BEALE AFB

SECOND FIVE-YEAR REVIEW REPORT

FINAL

SUBJECT: Second Five-Year Review Report (Final)

Attachment 1. 1973 Aerial Photos of Site OT-17 that were marked up with
trenches and pits

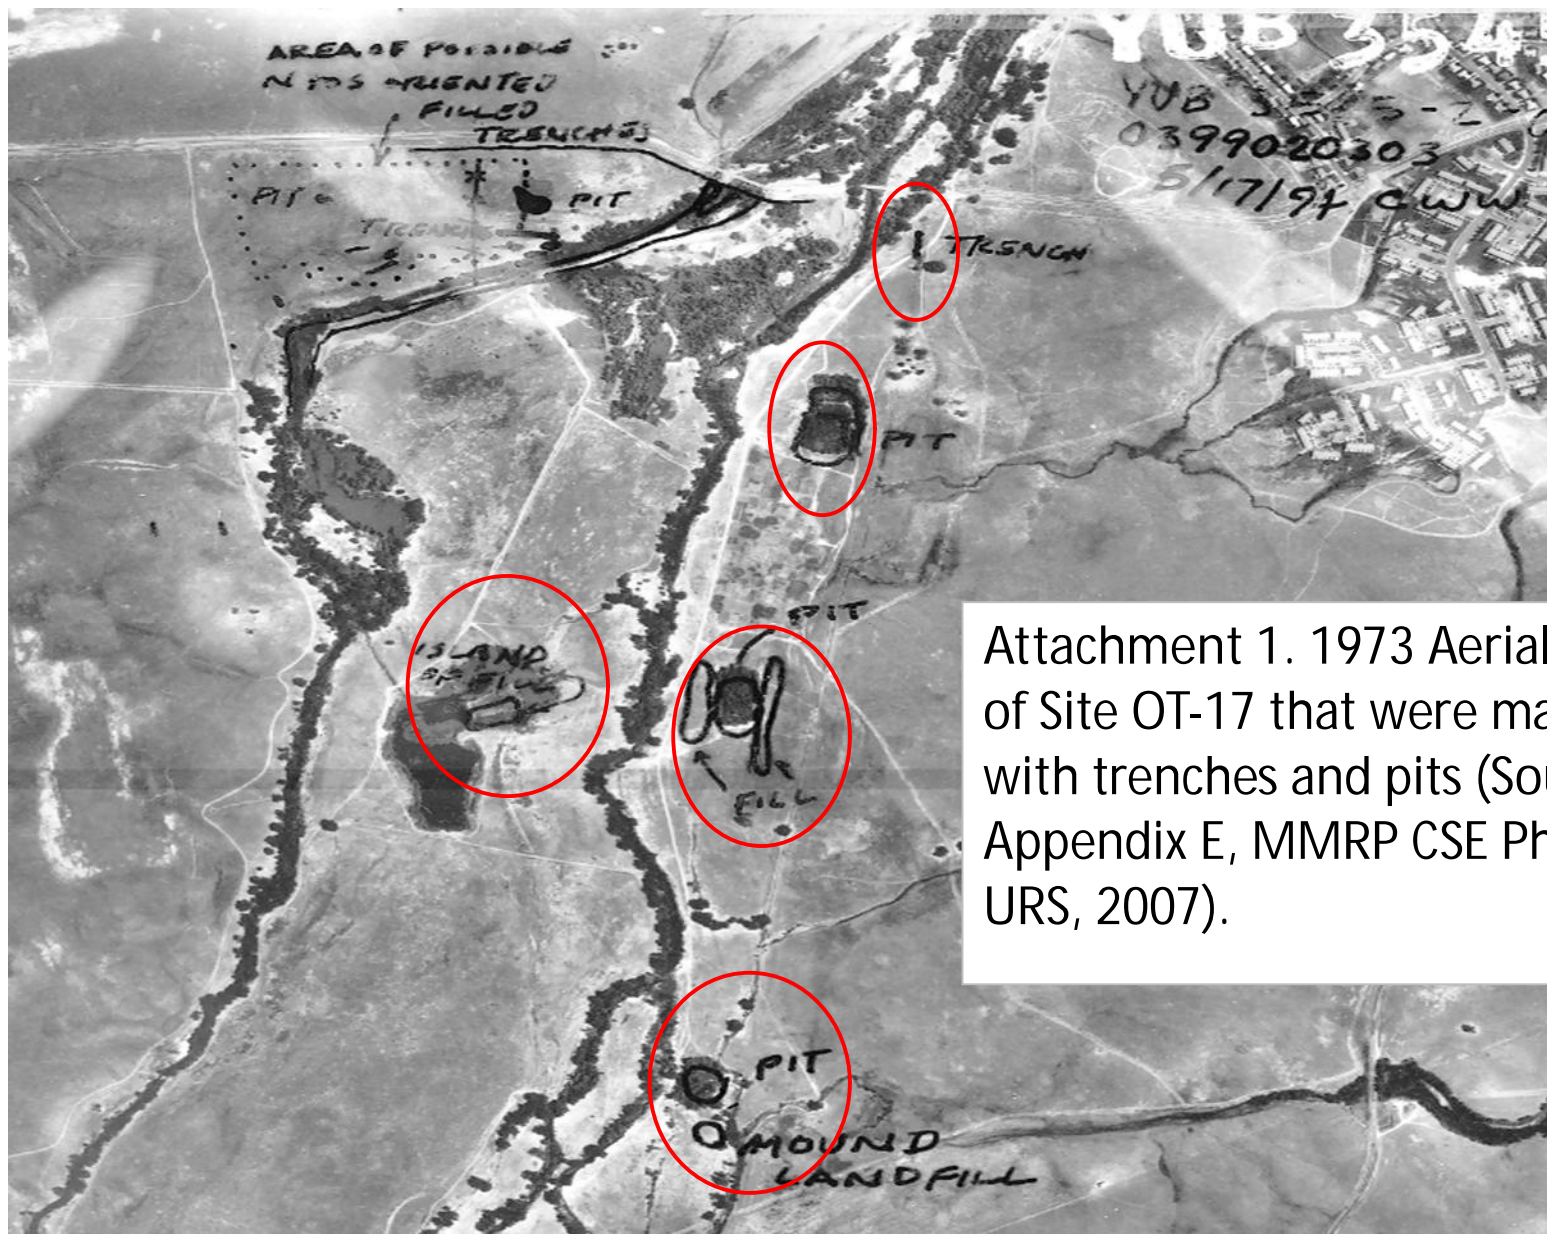
Attachment 1. 1973 Aerial Photos of Site OT-17 that were marked up with trenches and pits (Source: Appendix E, MMRP CSE Phase I, URS, 2007).
